PLANNING & ZONING COMMISSION

CITY OF PARKVILLE, MISSOURI

- A. Application for Final Development Plan for Capital Electric, a planned industrial development consisting of a 72,800 sq. ft. building for office, warehouse and shop uses on 45.82 acres, more or less, generally located at the southwest quadrant of the intersection of I-435 and Highway 45. Case No. PZ20-38; Greg Darkenwald, Capital Electric Line Builders, Inc., applicant

- B. Application for Final Development Plan for Creekside Hotel, a planned commercial development for Lodging – Hotel/Motel uses on Tract C of Creekside Commons (1.77 acres, more or less) generally located at the northwest quadrant of the intersection of I-435 and Highway 45. Case No. PZ20-39; Brian Mertz, Creekside Hotel Partners, LLC, applicant

Sheet
C12

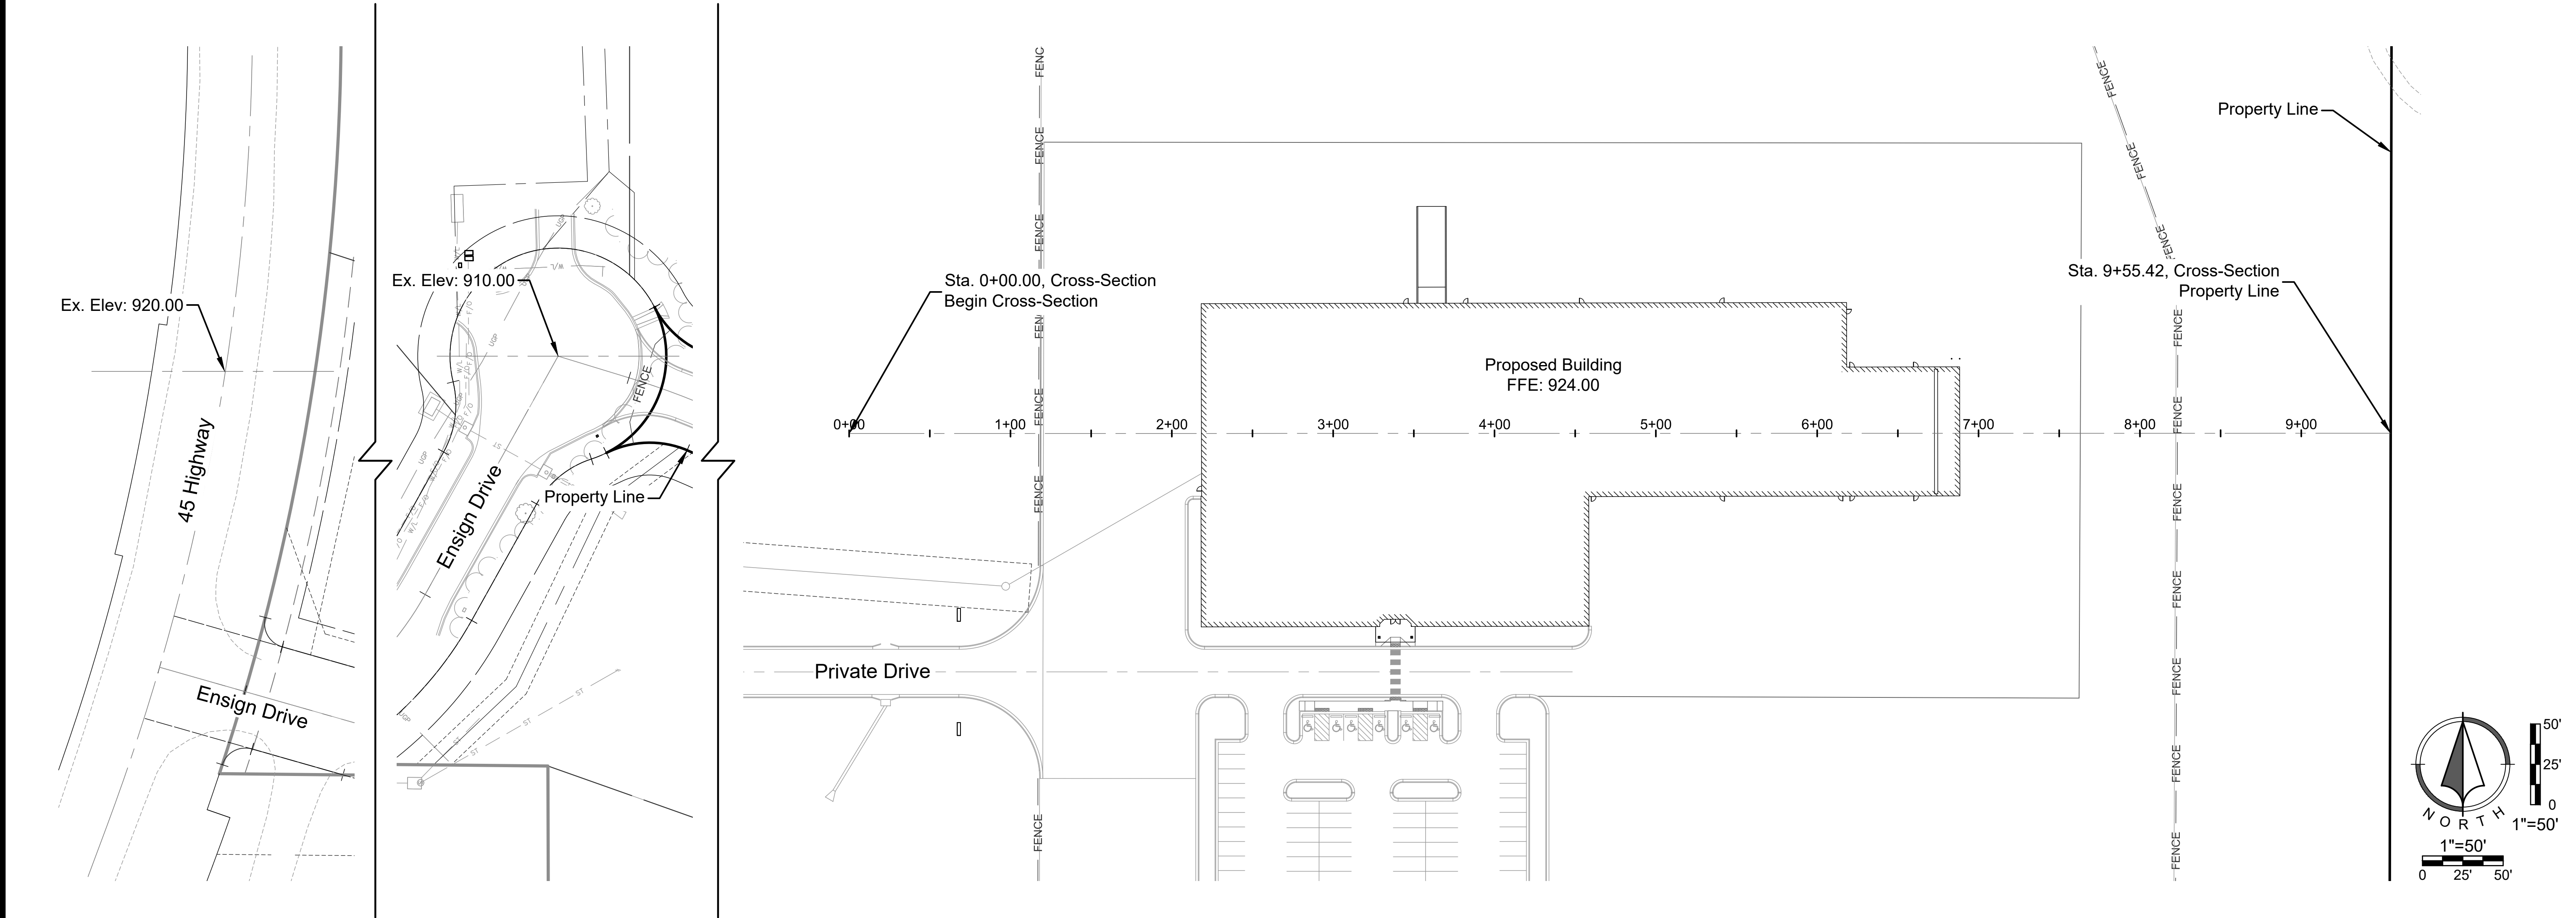
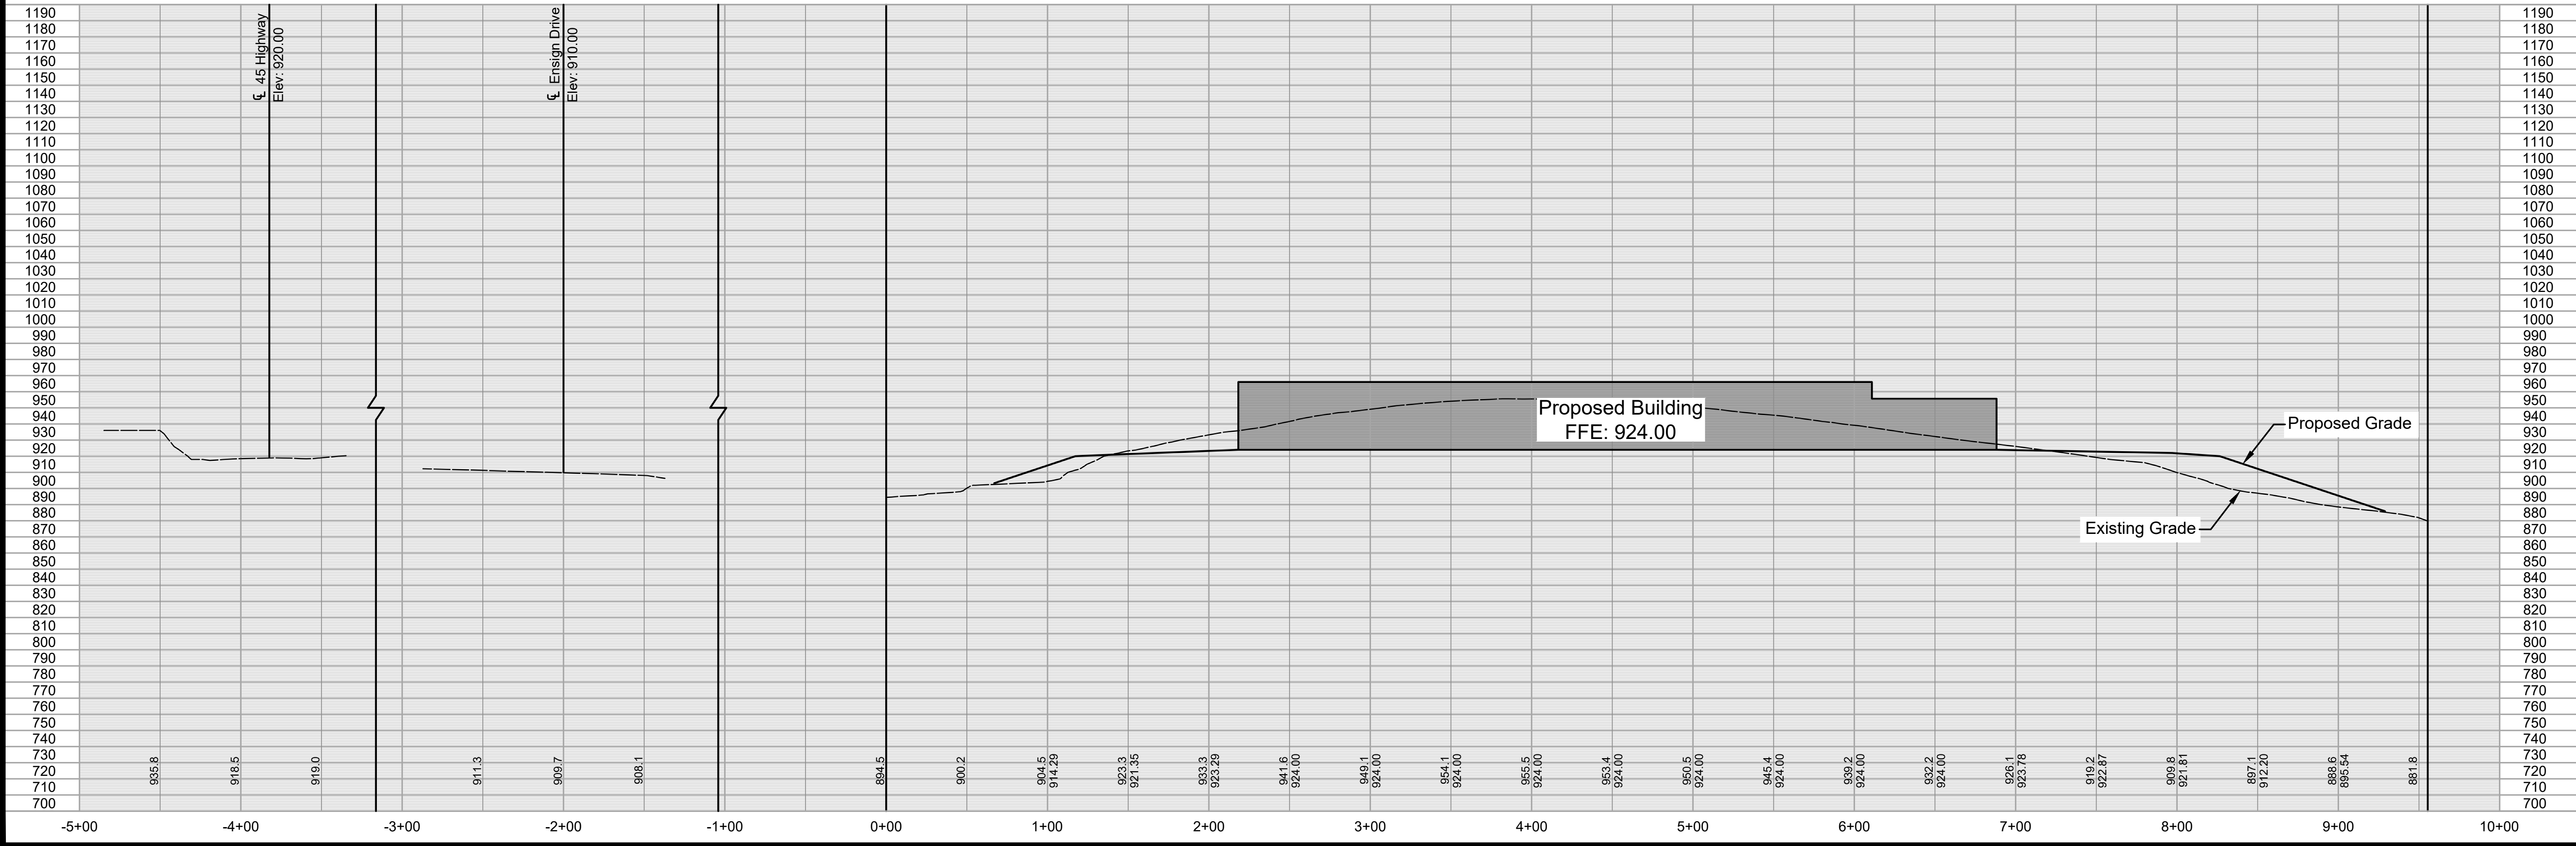
In terms of proportion, massing and scale, the size of the 72,800 sq. ft. Capital Electric building is an appropriate size for the "I-2" zoning district with context to the 40+ acre subject property. The applicant has provided an east-west cross-section drawing of the site to detail the proposed building in relation to Missouri Rout 45, Ensign Drive, existing grade and proposed grade (see Exhibit D.12); as well as a north-south cross-section drawing of the site to detail the proposed building in relation to the existing grade and proposed grade (see Exhibit D.13).

Response: Cross section views have been added on Sheets C12 & C13

Standard Details (Sheet C04)

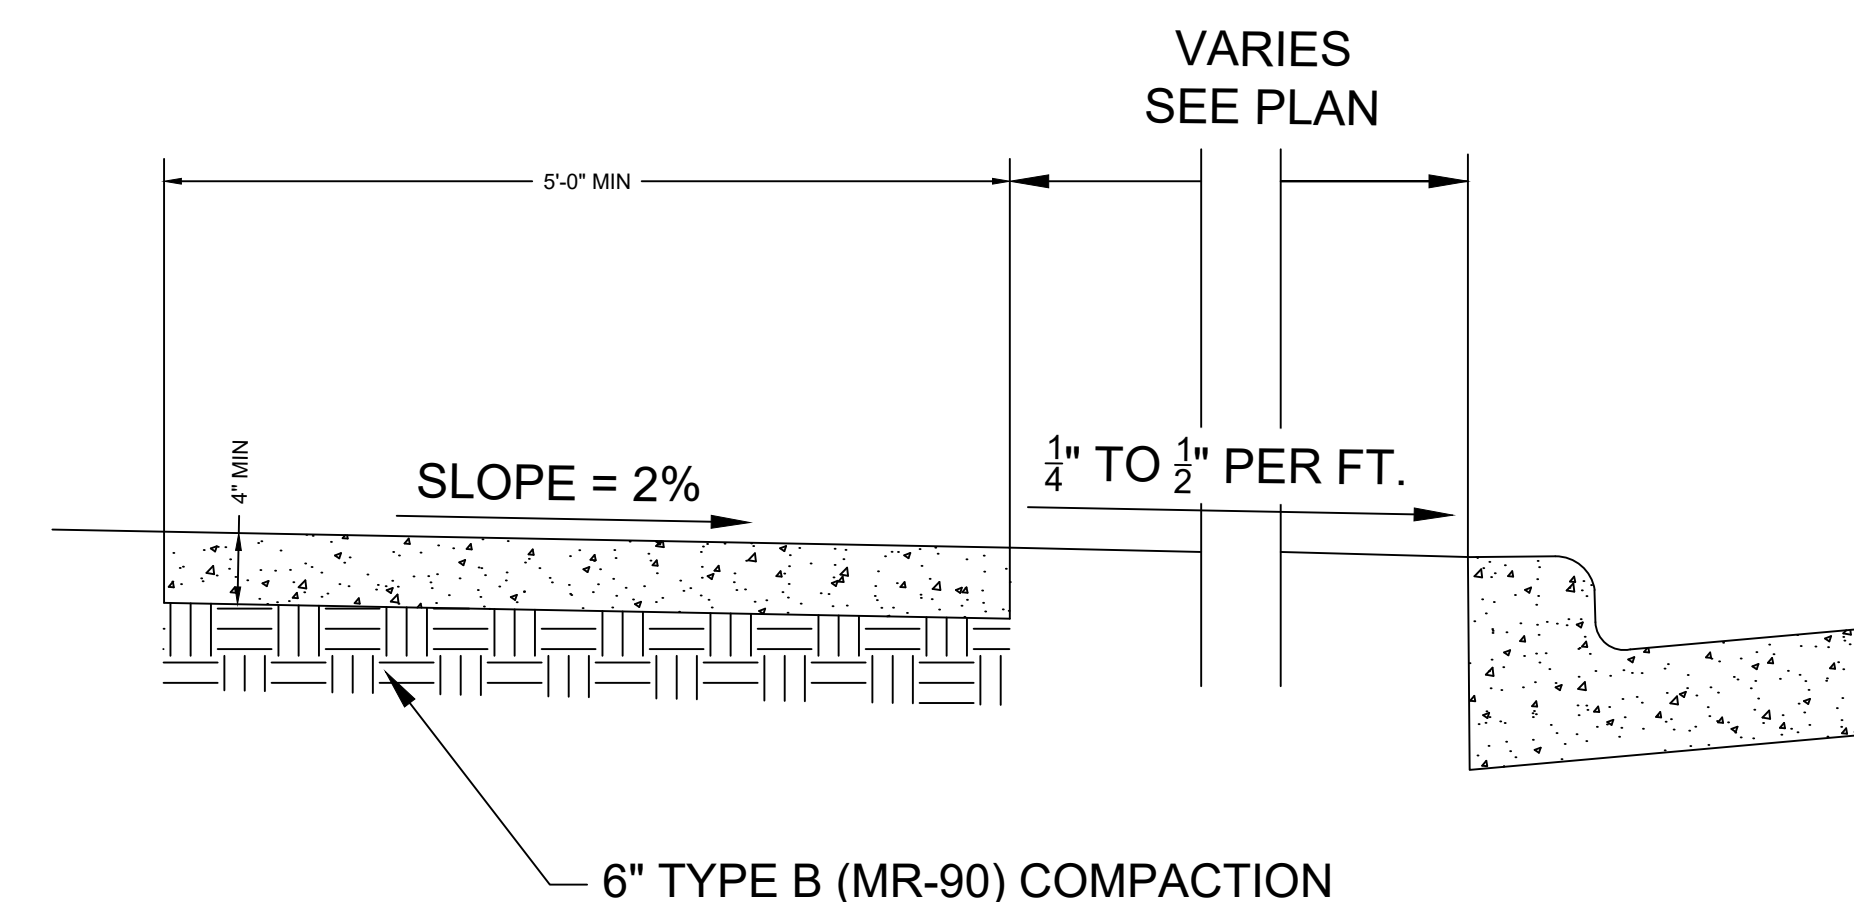
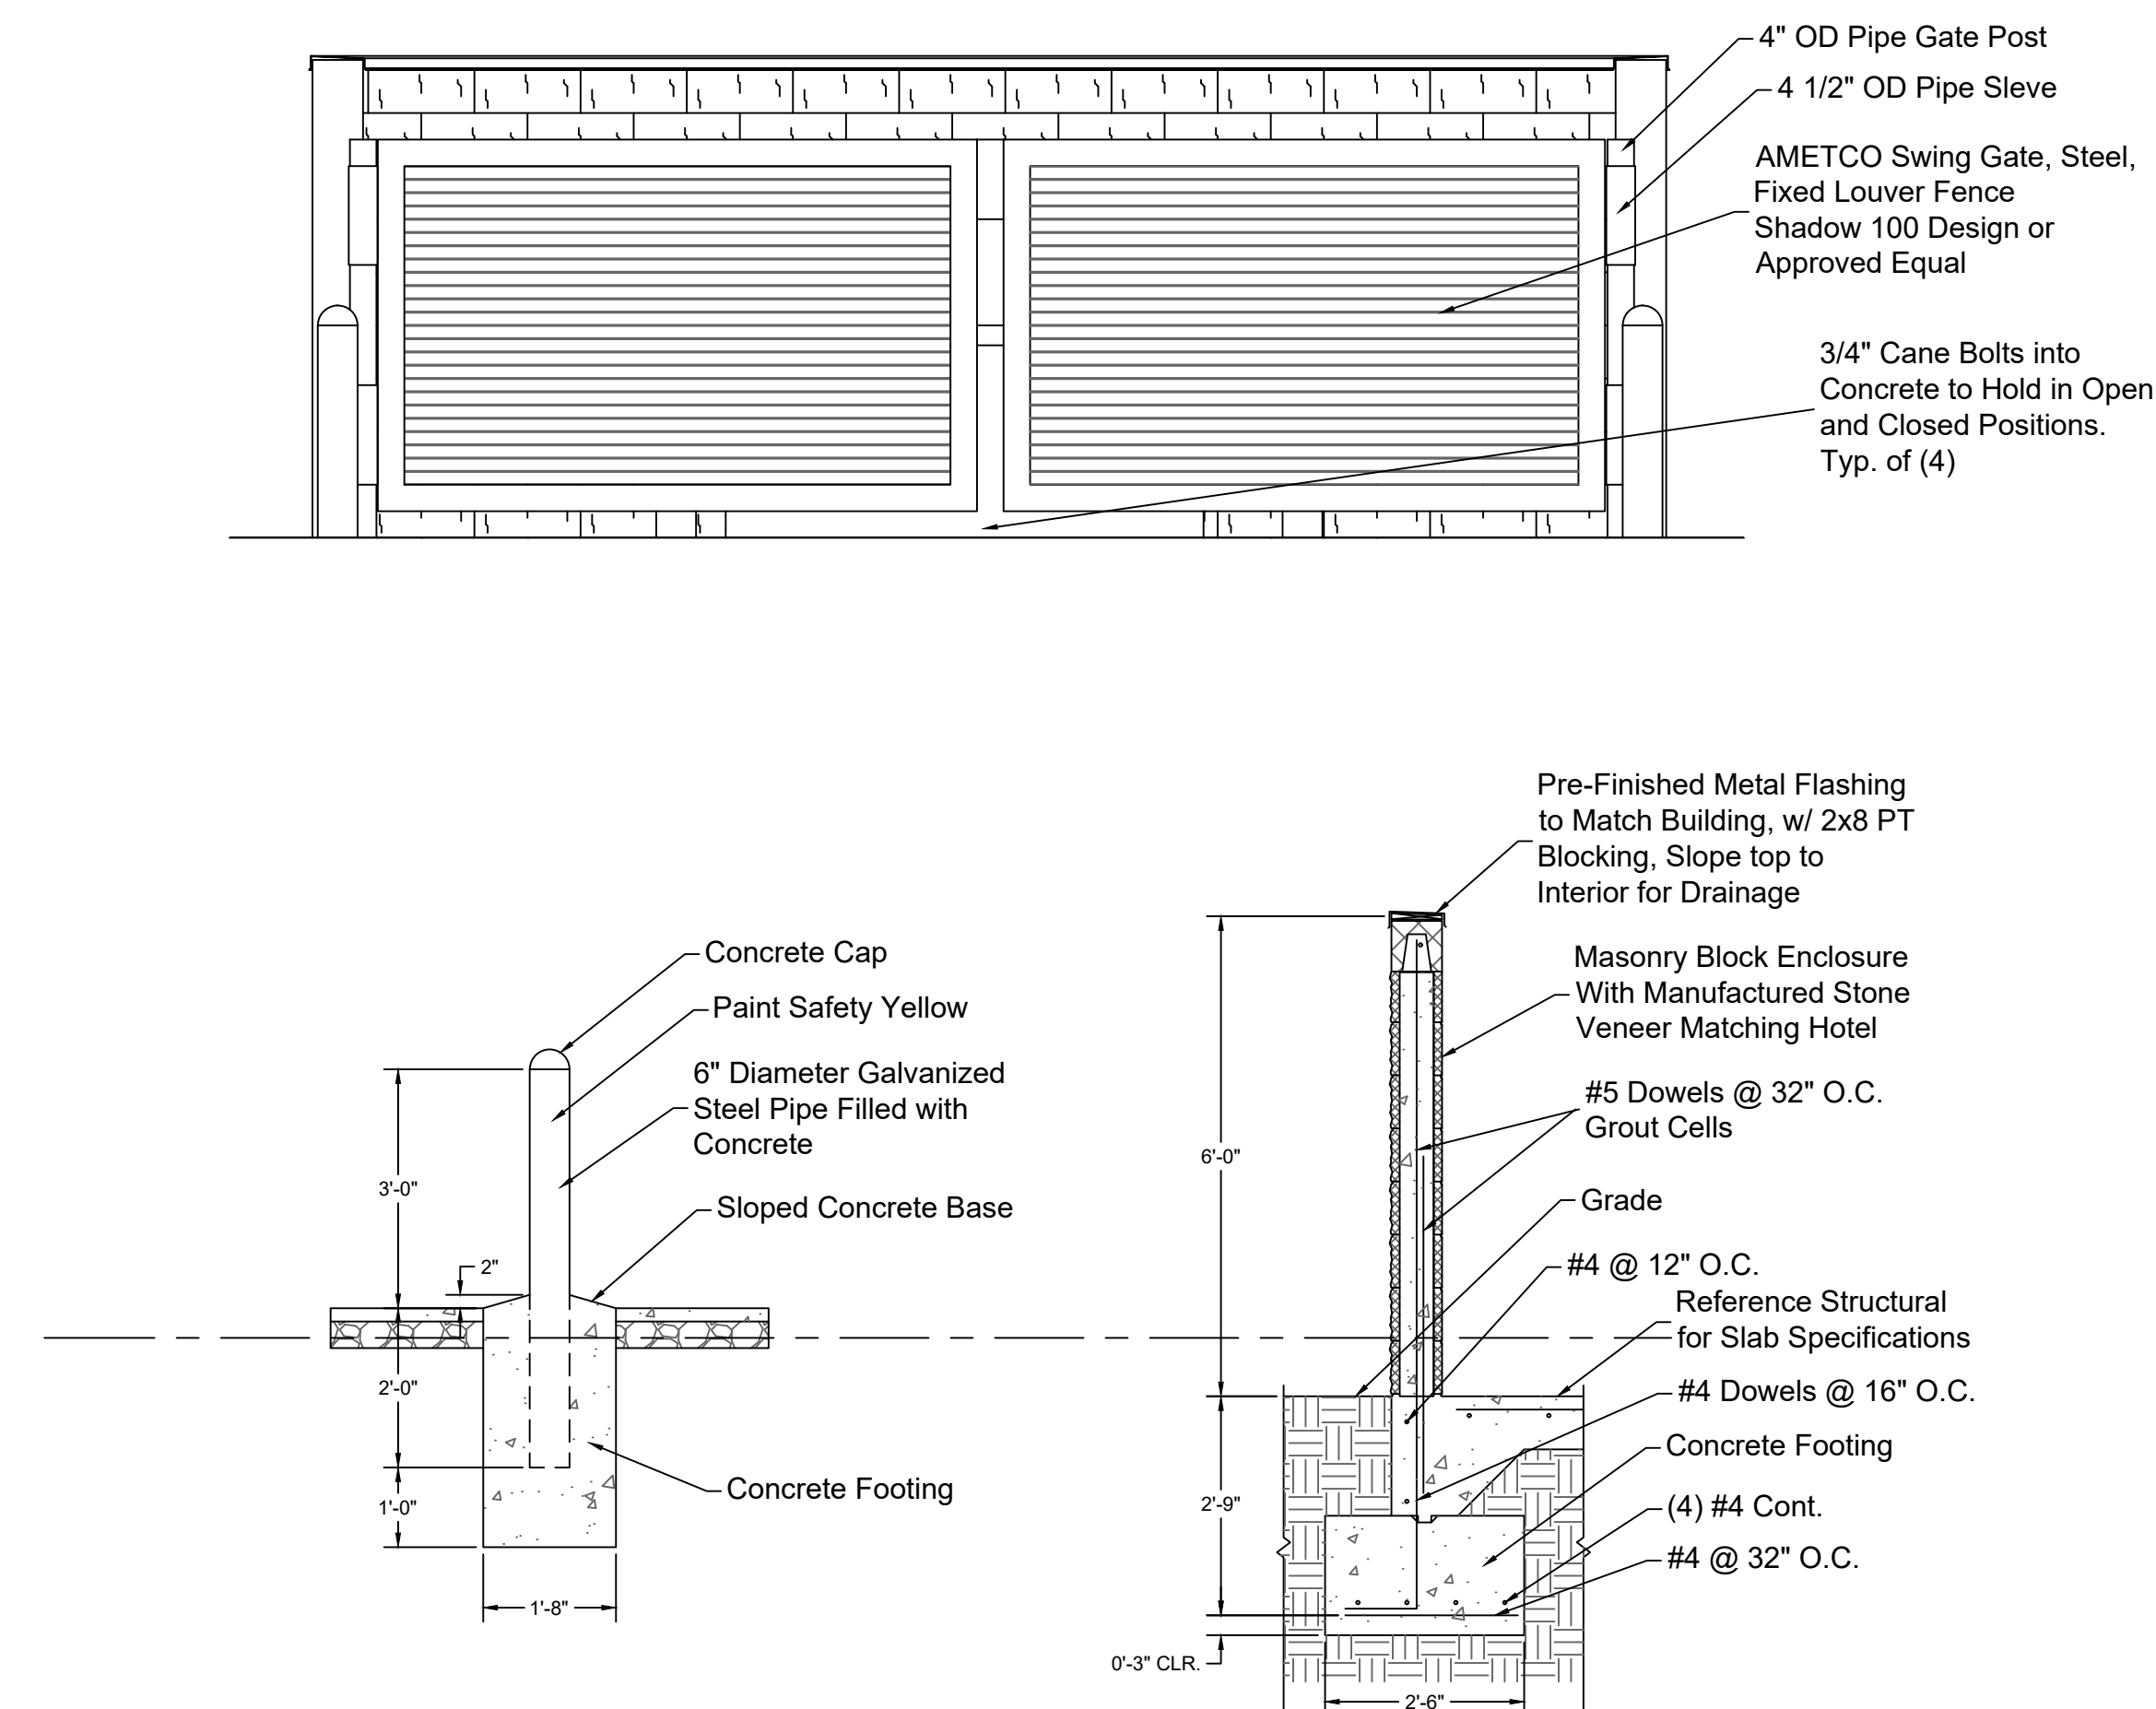
13. **Bumper Blocks** – Please show bumper blocks on the ADA parking stall detail exhibit.
14. **Trash Enclosure Description** – Please include a description for the trash enclosure detail exhibit, similar to what is provided on Sheet C03.
